**CITY OF WINTER GARDEN  
DEVELOPMENT REVIEW COMMITTEE  
MINUTES  
May 25, 2022**

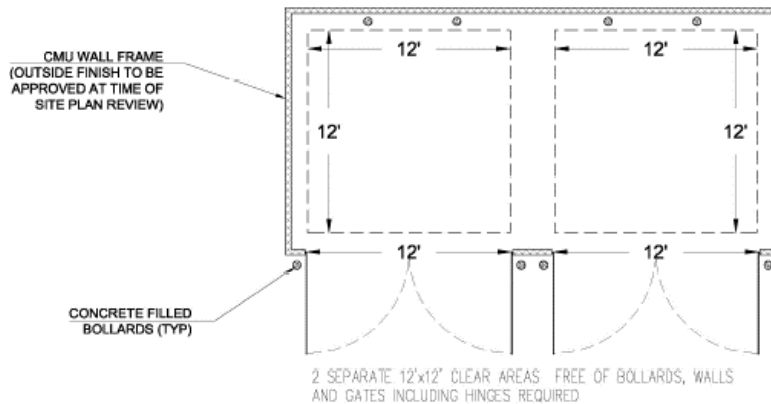
- 16. **Dumpster detail is not showing the minimum inside clearance of 12' both ways. Please follow the City's dumpster layout detail standards (see below).** Applicants discussed potential options for dumpster layout. Applicant understood the requirements and will review and provide details in next submittal.

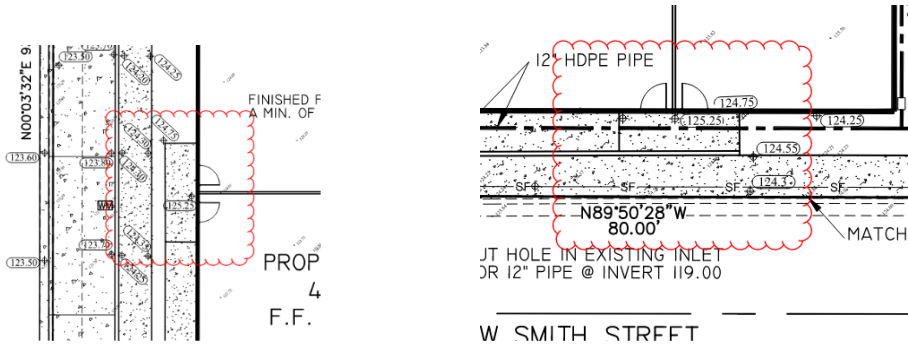
- 10. A community meeting will be required.** This is a city requirement. Applicant understood.
- 11. Please also provide pedestrian steps at both entrances (see below) in addition to the ADA ramps. The difference in grade should allow one or two stair steps to the entrance.** Applicant discussed steps and will add them back into the project. This will be part of the revised submittal.

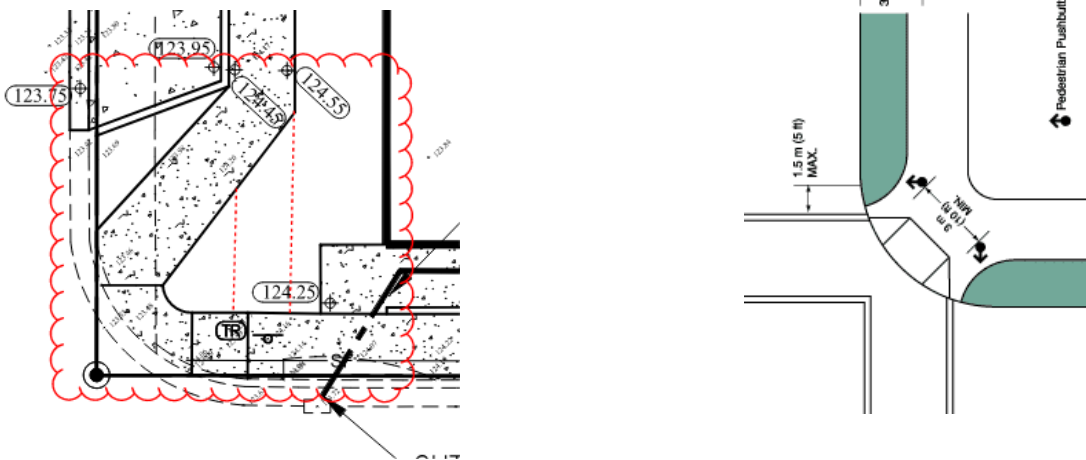
**12. Please connect the sidewalks with a more direct route in order to avoid pedestrian shortcuts through the grass (see below for examples). Either make a second route or something more curvilinear.** Sidewalk aspect of project was discussed and these connections will be added.
